Company	Trenz Electronic GmbH
PCN Number	PCN-20180911
Title	PCN-20180911 TE0714-02-*-2IC6 SPI Flash Change
Subject	BOM change
Issue Date	2018-09-11

This change affects Trenz Electronic TE0714-02 SoMs: TE0714-02-*-2IC6.

N25Q128A11ESE40G	MT25QU128ABA1ESE-0SIT

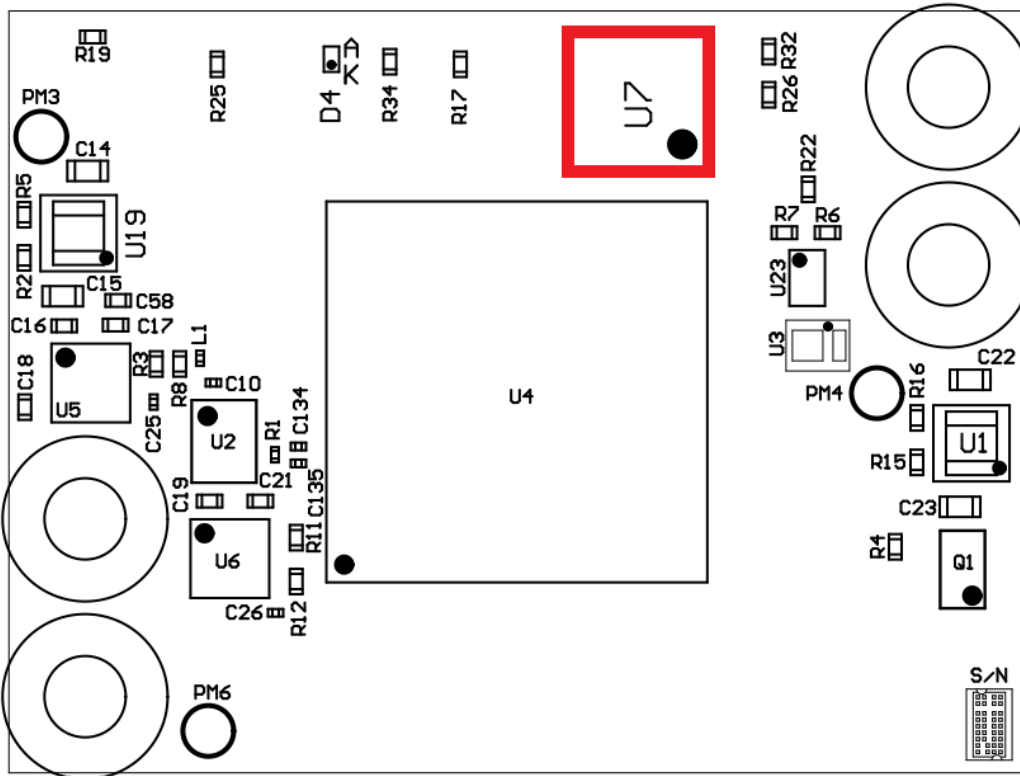
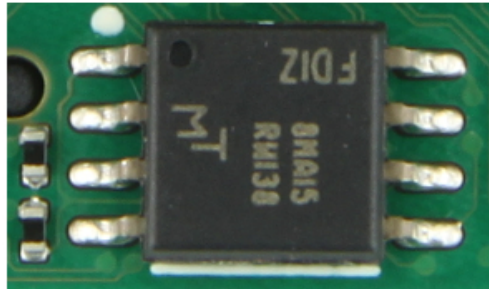
#1 Change SPI Flash from N25Q128A11ESE40G to MT25QU128ABA1ESE-0SIT

Reason: N25Q128A11ESE40G became obsolete.

Impact: JEDEC ID changed from BB18h to BA18h.

Locate Flash on topside of PCB:
